Access Compliance Report

Public Rights-of-Way

(Curb Ramps)

Intersection ID: 48863	Main Street: STEELE_CREEK_RD	Cross Street: WALKER_BRANCH_DR	Location: SE
ADA ID: EB9A2FE9510D	Ramp Type: Perp	Initial Pass/Fail: Fail	Overall Compliance: No
Codes/Mitigation Info/Possible Solution			Severity Score: 10
			Field Measurements/Component Compliance

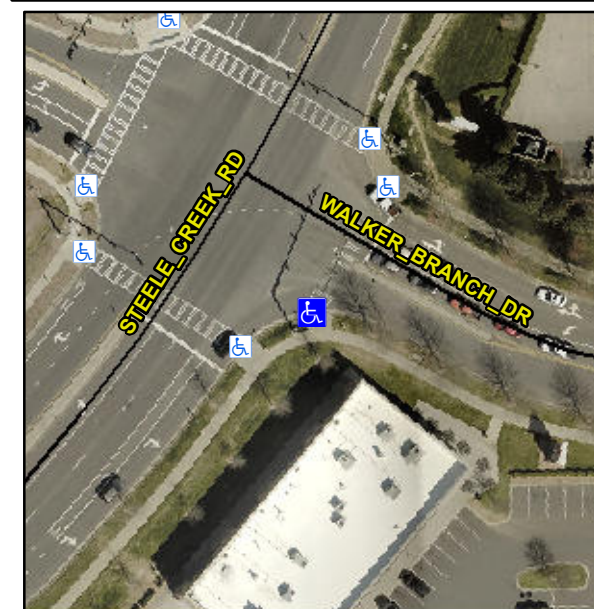
Not Found, R304.5.1, R304.5.3

Compliance	Description	Data	Compliance	Description	Data
N/A	Ramp Length (in)	96.0	Yes	Ramp Slope (%)	6.5
No	Ramp Width (in)	44.0	No	Ramp XSlope (%)	3.2
N/A	Flare Type LT	N/A	N/A	Flare Type RT	N/A
N/A	Flare Slope LT (%)	N/A	N/A	Flare Slope RT (%)	N/A
N/A	Flare Traversable LT?	N/A	N/A	Flare Traversable RT?	N/A
N/A	Landing Length (in)	N/A	N/A	DWS Provided?	N/A
N/A	Landing Width (in)	N/A	N/A	DWS Contrast?	N/A
N/A	Landing Slope (%)	N/A	N/A	DWS Length (in)	N/A
N/A	Landing X Slope (%)	N/A	N/A	DWS Full Width?	N/A
N/A	Landing Curb? (Y/N)	N/A	N/A	DWS Offset (in)	N/A
N/A	Shared Landing?	N/A			
N/A	Gutter Ponding?	N/A	N/A	Gutter Slope (%)	N/A
N/A	Gutter Lip Ht (in)	N/A	N/A	Gutter X Slope (%)	N/A
N/A	Painted X Walk1?	Yes	N/A	Painted X Walk2?	N/A
	X Walk 1 Direction	To NE		X Walk 2 Direction	N/A
N/A	X Walk 1 Width (in)	104.0	N/A	X Walk 2 Width (in)	N/A
	X Walk 1 Slope (%)	3.0		X Walk 2 Slope (%)	N/A
	X Walk 1 X Slope (%)	1.8		X Walk 2 X Slope (%)	N/A

Possible Solutions:

Remove & Replace Entire Ramp.
